ELECTRICAL LEGEND & NOTES

FORT WEAVER ROAD
ROUTE H-1 TO SOUTH OF
FARRINGTON HIGHWAY

CONTRACT CHANGE ORDER NO. 10
HIGHWAY LIGHTING REVISION

FAUSP NO. M-7600(1)

DETAIL 1/E7A

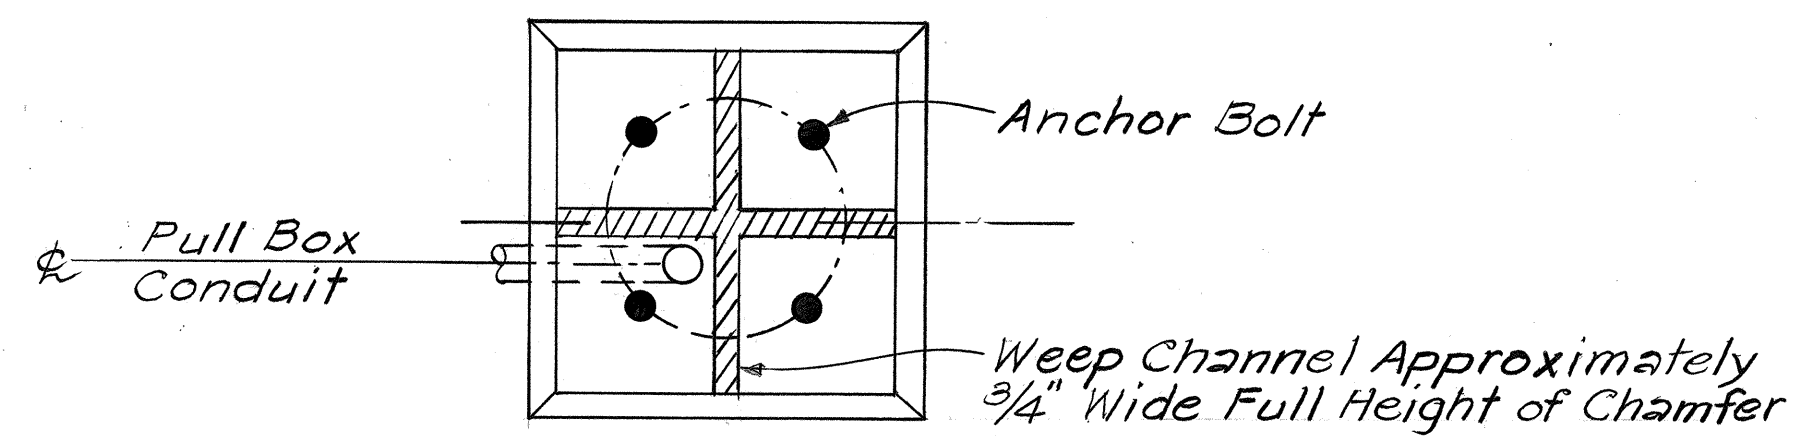
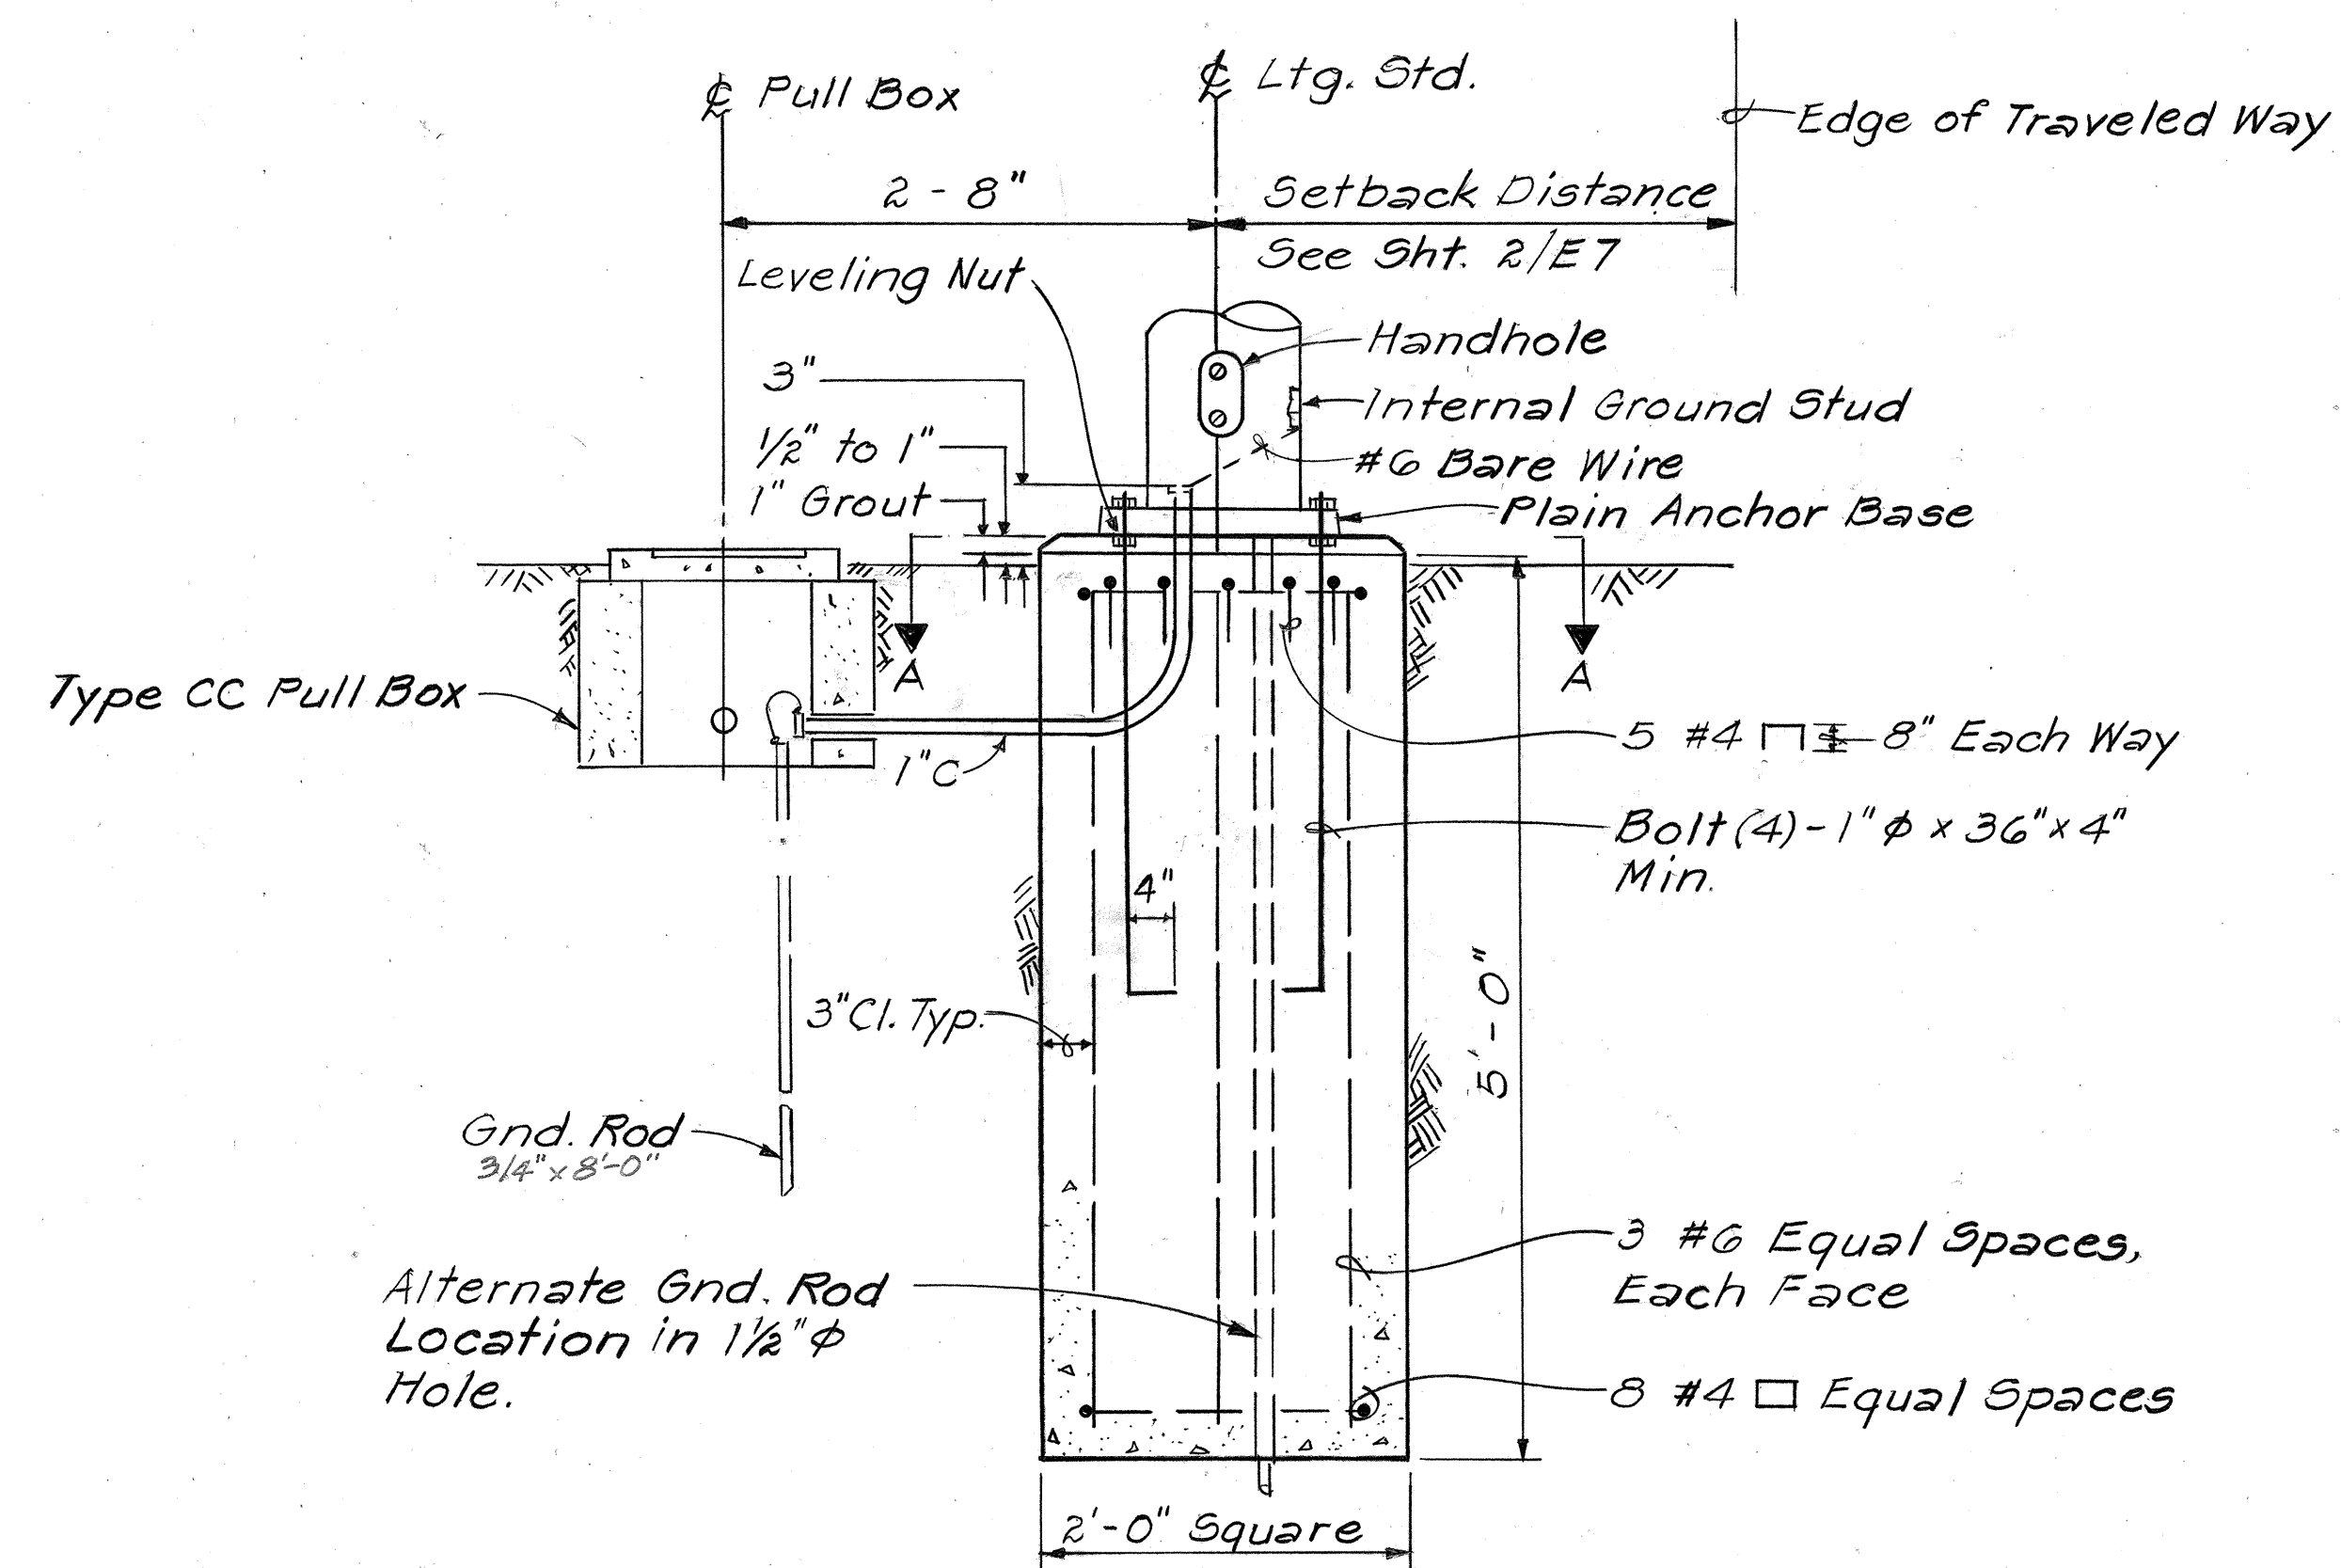
LIGHTING STANDARD FOUNDATION, PLAIN BASE
(LUMINAIRES #36, #37, #38, #39, #51 & #56 ONLY)
